Coal Combustion Residue Impoundment

Round 12 - Dam Assessment Report

Keystone Generating Station

Ash Filter Ponds & Thermal Pond

Figure 5.3.3-1 Outside slope and seep area of main embankment dam impounding the Thermal Pond – east side viewed north.

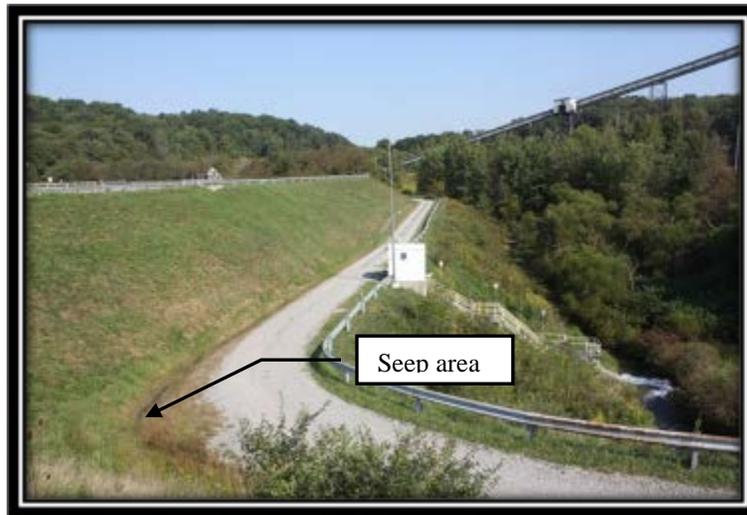
Investigate and provide documented field evidence that the source of the seep area observed along the access road berm ditch on the downstream right side of the main dam is not seepage through the embankment due to liner failure. It is suggested that this investigation include at least two temporary observation wells, with one of these installed on the dam crest above the seep area to check for a phreatic surface or line of seepage through the dam embankment. The other observation well would preferably be installed on the railroad embankment, if feasible, or on the berm next to the seep area.

slope above the south part of the access road (see Figure 5.3.3-1). Dam inspection reports have reported the seep. No scarps, sloughs, significant bulges, cracks, depressions or other indications of slope instability were observed along the slope. The outside slope of the dam embankment on the north side of the Thermal Pond was observed to have a tall thick growth of grasses/weeds, as shown in Figure 5.3.3-3. Although the grasses/weeds did not appear to be as well maintained as on the main embankment section on the east side, this slope also appeared stable and free of significant erosion. It is noted that this slope forms the south inside slope of the retired basin on the north side of the Thermal Pond. Several animal holes were noted all along the upper part of the outside slope of the low embankment on the south side of the Thermal Pond. A view of one animal hole shown in Figure 5.3.3-4 is typical.
